RE: **Comments of the Minnesota Department of Commerce**  
Docket No. E001/M-13-249

Interstate Power and Light Company's 2012 Annual Safety, Reliability, and Service Quality Report and Proposed SAIFI, SAIDI and CAIDI Indices for 2013.

COMMENTS OF THE  
MINNESOTA DEPARTMENT OF COMMERCE  
DIVISION OF ENERGY RESOURCES

DOCKET NO. E001/M-13-249

**Graph 1: SAIDI Performance vs. Goals  
 Winnebago Work Center**

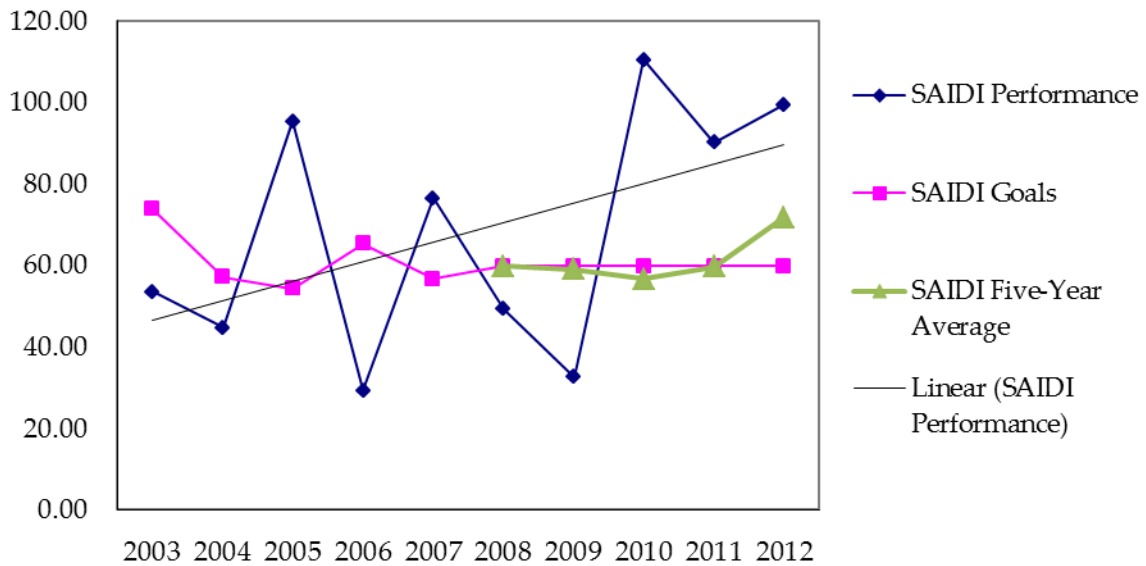
The Department notes that Graphs 1 through 3, along with Table 3 above, illustrate the high performance variability that has occurred in this relatively small work center. While IPL has achieved its goals five out of the last ten years on SAIDI and SAIFI, as can be seen in Graph 3, the CAIDI goal was only met twice in the past ten years.

Considering the declining trend in SAIDI performance and the difficulty IPL appears to be having in meeting its CAIDI goals, it appears to the Department that goals that continue to exert a downward pressure on SAIDI and CAIDI would be more desirable for 2013 than a stricter SAIFI goal. Therefore, the Department recommends that the Commission set IPL's 2013 goals in the Winnebago work center at the same level as those set for 2008 through 2012.

**Graph 4: SAIDI Performance vs. Goals  
 Albert Lea Work Center**

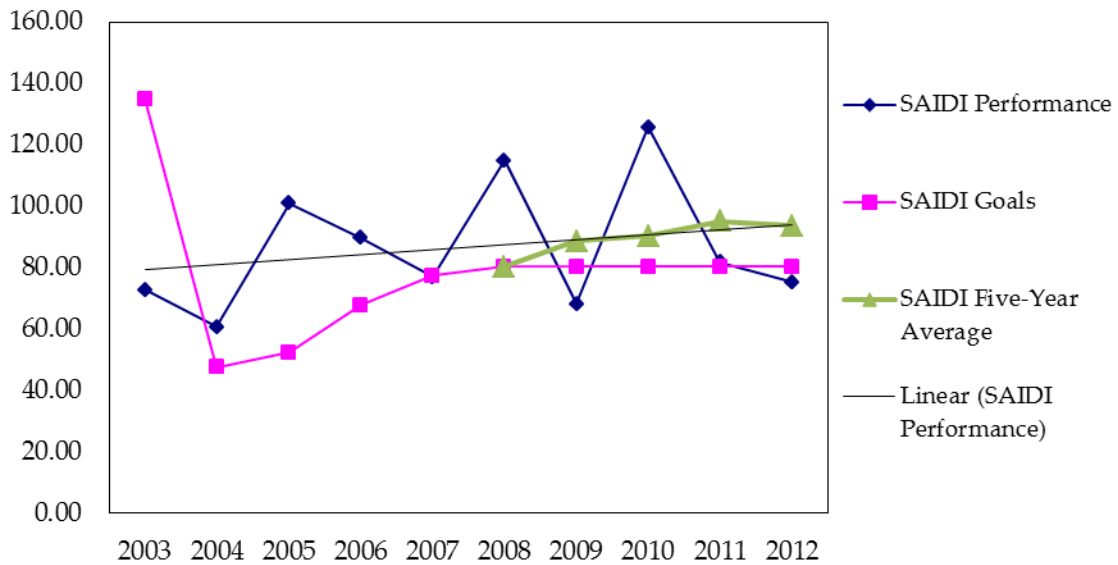
Despite improvements over 2011 in both SAIDI and CAIDI, IPL has only achieved its SAIFI goal three times and SAIDI and CAIDI goals four times each over the last ten years.<sup>16</sup> In addition, there appears to be a slight declining trend in both SAIDI and SAIFI performances since 2003. The 2012 goals shown in Table 8, if maintained for 2013, would place slightly more downward pressure on SAIDI and SAIFI while maintaining a CAIDI goal closer to the 5-year average. The Commission approved these same goals for 2008 through 2012. Therefore, the Department recommends that the goals for the Albert Lea work center be maintained at the same level for 2013 as were approved by the Commission for 2008 through 2012.
